Access Compliance Report

Public Rights-of-Way

(Curb Ramps)

Intersection ID: 50666	Main Street: SPRINGPOINT_LN	Cross Street: SAMUEL_NEEL_RD	Location: SE
ADA ID: 62AAAF0D907D	Ramp Type: PerpDiag	Initial Pass/Fail: Fail	Overall Compliance: No
Severity Score: 50			
Codes/Mitigation Info/Possible Solution		Field Measurements/Component Compliance

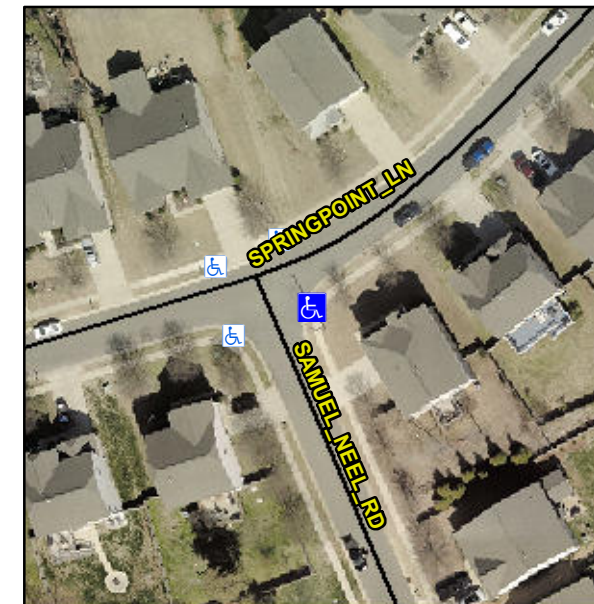
Not Found, R304.2.2, R304.5.3

Compliance	Description	Data	Compliance	Description	Data
N/A	Ramp Length (in)	48.0	No	Ramp Slope (%)	15.2
Yes	Ramp Width (in)	48.0	No	Ramp XSlope (%)	9.9
N/A	Flare Type LT	N/A	N/A	Flare Type RT	N/A
N/A	Flare Slope LT (%)	N/A	N/A	Flare Slope RT (%)	N/A
N/A	Flare Traversable LT?	N/A	N/A	Flare Traversable RT?	N/A
N/A	Landing Length (in)	N/A	N/A	DWS Provided?	N/A
N/A	Landing Width (in)	N/A	N/A	DWS Contrast?	N/A
N/A	Landing Slope (%)	N/A	N/A	DWS Length (in)	N/A
N/A	Landing X Slope (%)	N/A	N/A	DWS Full Width?	N/A
N/A	Landing Curb? (Y/N)	N/A	N/A	DWS Offset (in)	N/A
N/A	Shared Landing?	N/A			
N/A	Gutter Ponding?	N/A	N/A	Gutter Slope (%)	N/A
N/A	Gutter Lip Ht (in)	N/A	N/A	Gutter X Slope (%)	N/A
N/A	Painted X Walk1?	No	N/A	Painted X Walk2?	No
	X Walk 1 Direction	To NW		X Walk 2 Direction	To SW
N/A	X Walk 1 Width (in)	N/A	N/A	X Walk 2 Width (in)	N/A
	X Walk 1 Slope (%)	5.9		X Walk 2 Slope (%)	3.2
	X Walk 1 X Slope (%)	7.2		X Walk 2 X Slope (%)	8.3

N/A	Ramp inside XWalk1?	N/A	N/A	Ramp inside XWalk2?	N/A
	Road Slope (%)	9.1	N/A	Clear Space?	N/A
	Road X Slope (%)	1.4	N/A	Clear Space to XWalk (in)	N/A
N/A	Any Obstructions?	N/A	N/A	Storm Grate/Utility Hazard?	N/A
	Obstruction Type			Storm Grate/Utility Type	
		N/A			N/A
			Yes	Surface Condition? (G/P)	Good

Remove & Replace Curb Ramp With Two New Directional Ramps or Equivalent.
